OFFICE OF THE COUNCIL
MEETING PACKET FOR THE
COMMITTEE OF THE WHOLE
NOVEMBER 19, 2025
6:00 P.M.

1. The subject matter of Petition 2025-07-02-15, submitted by Mannik & Smith Group, on behalf of Clean Express Car Wash, requesting waiver use approval to operate an Auto-Wash Establishment, at 38888 Six Mile Road, located at the N.E. corner of Fox Drive and Six Mile Road in the S.W. ¼ of Section 7. (CR 340-25).

Plan Review for: **Clean Express Car Wash**
38888 6-Mile Rd, Livonia MI
Petition 2025-07-02-15

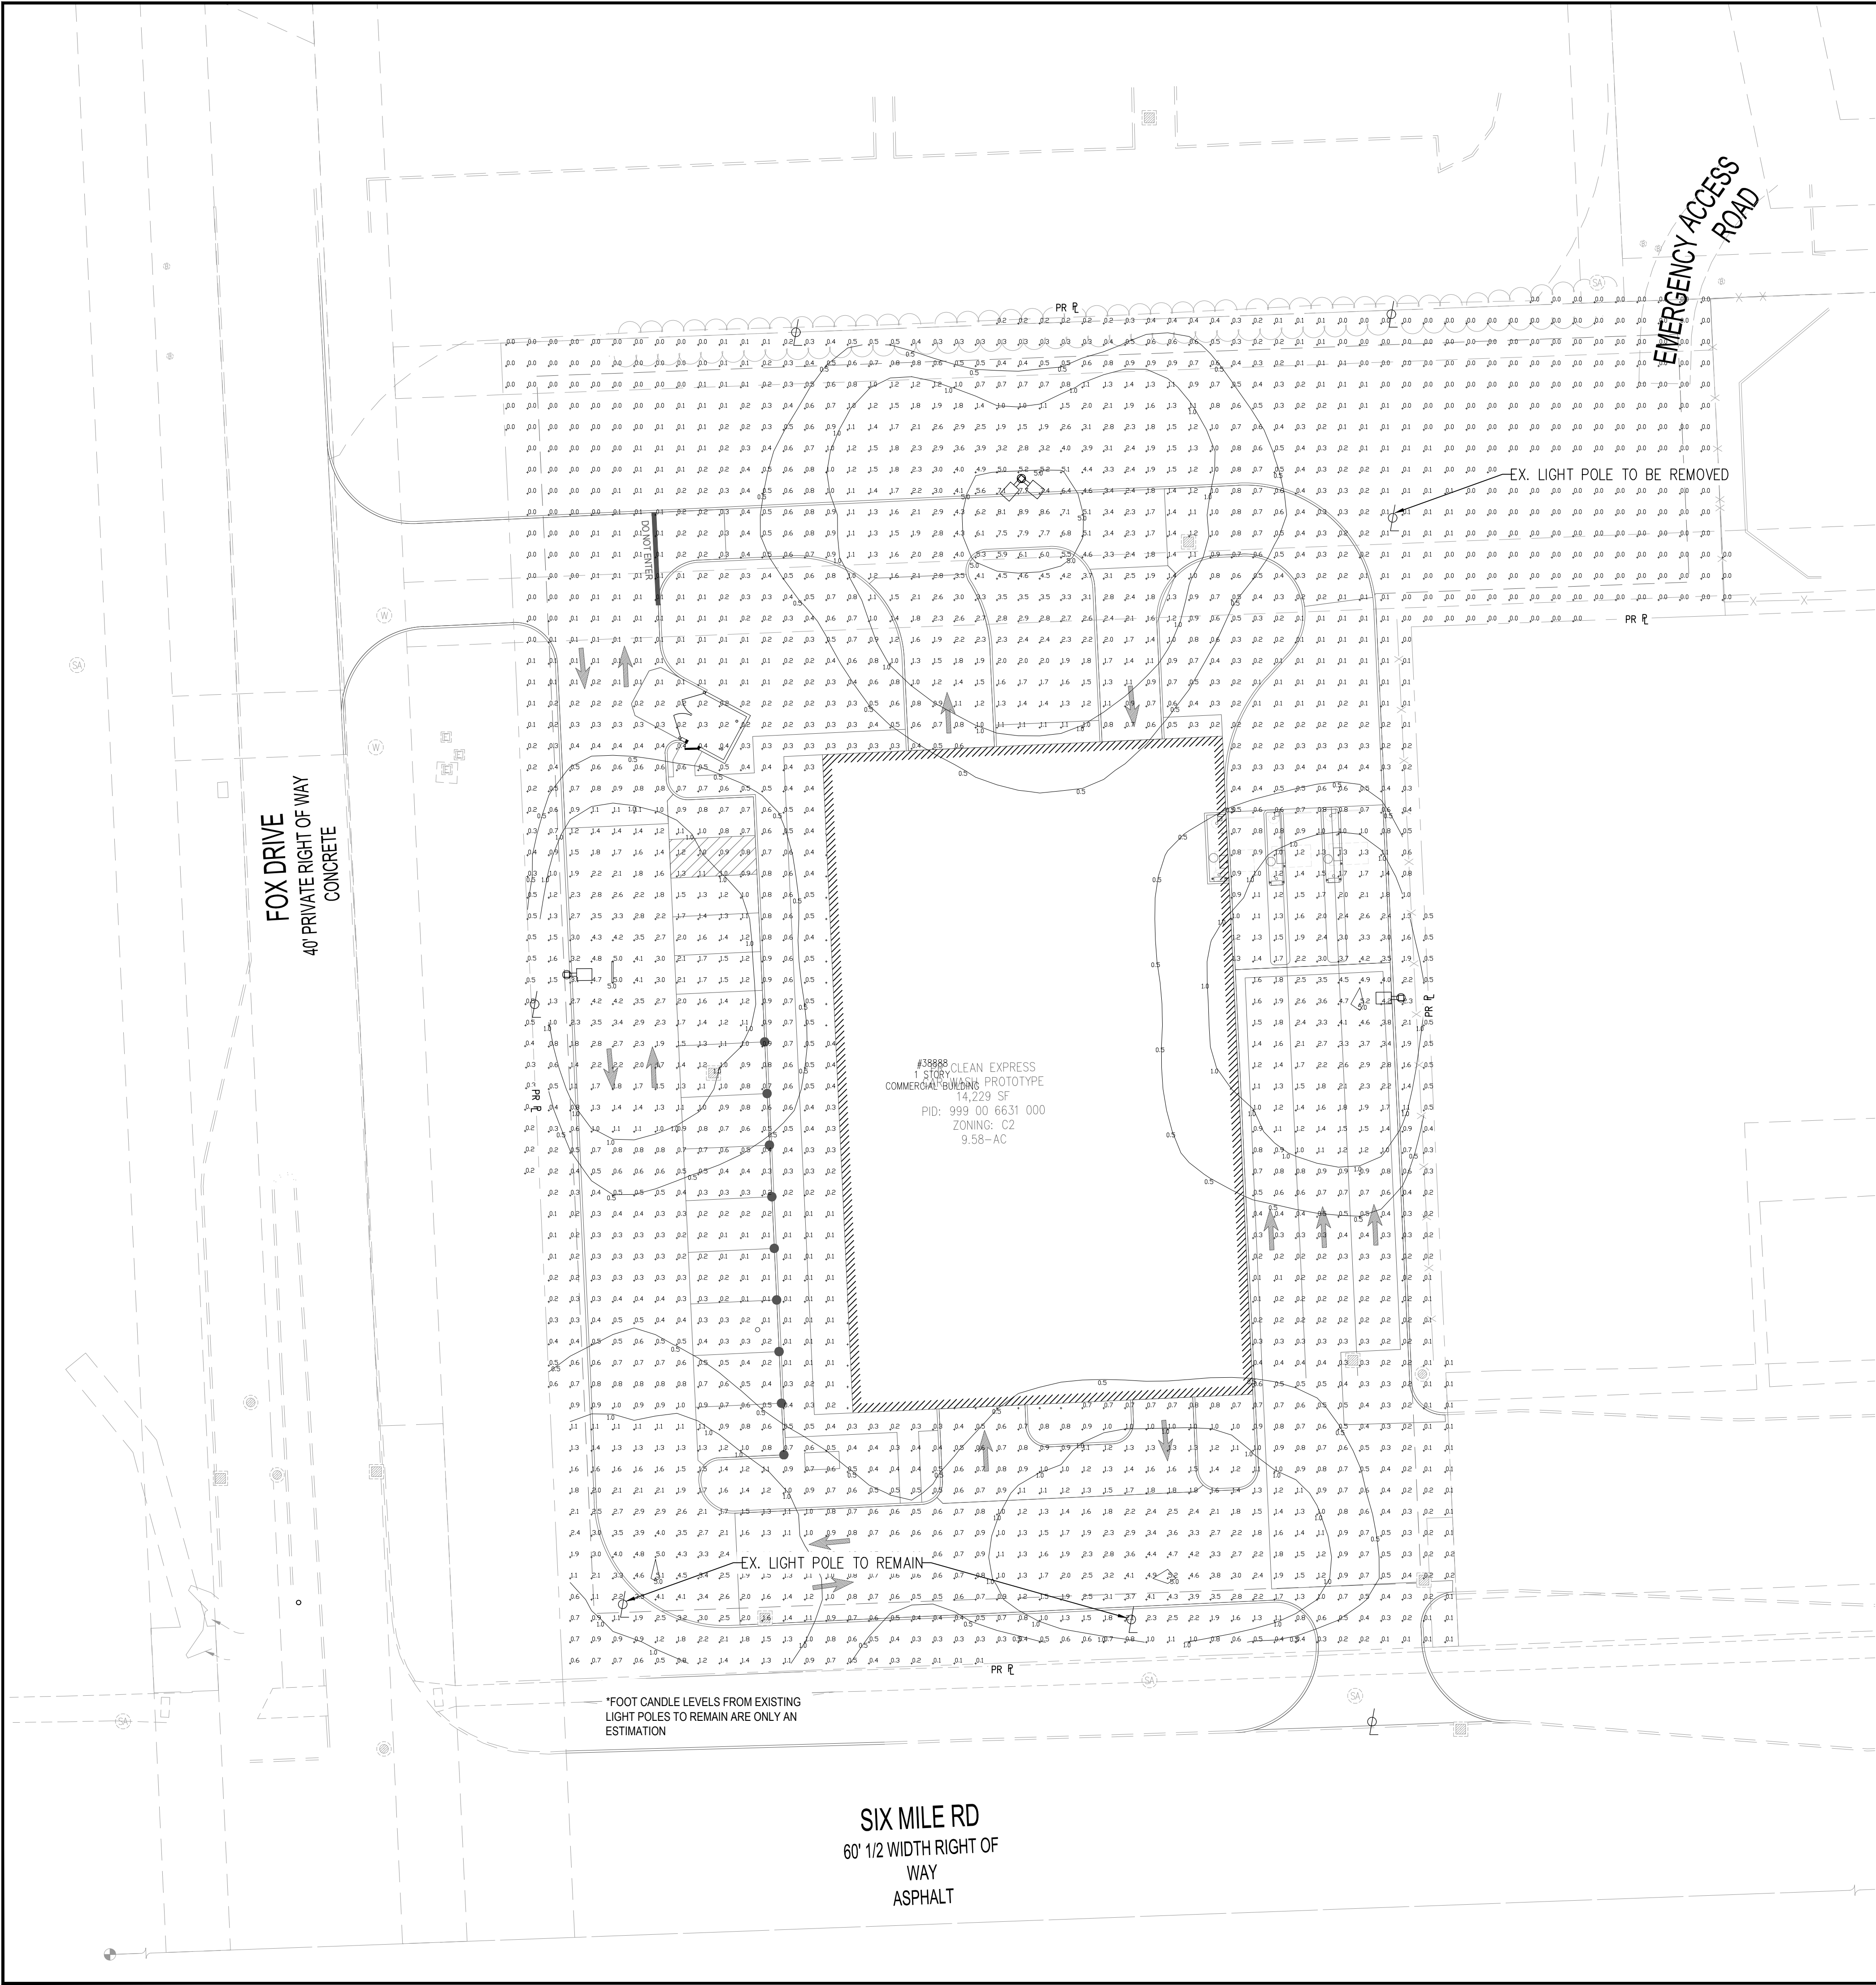
The photometric plan, Sheet C600, submitted July 9, 2025, shows footcandles at or below 0.5 at the property line with adjacent properties. Two (2) existing light poles are scheduled to remain on the property. Three (3) proposed 18-foot (18') lighting fixtures; one single lighting fixture on the east side of the property over the three (3) service lanes. The other single lighting fixture over the west side parking lot. The double-lighting fixture is over the twelve-foot (12') drive north of the building providing illumination to the exit of the indoor vacuums and the entrance to the car wash. The average illumination levels on the car wash property appear consistent with the preexisting ones, including those on the adjoining properties. For these reasons, the Planning Department has no objection to the lighting plan regarding the overall illumination.

4. That the Photometric Plan marked Sheets C600 dated July 9, 2025, as revised, prepared by Mannick Smith Group is hereby approved and shall be adhered to, except as may be modified below.
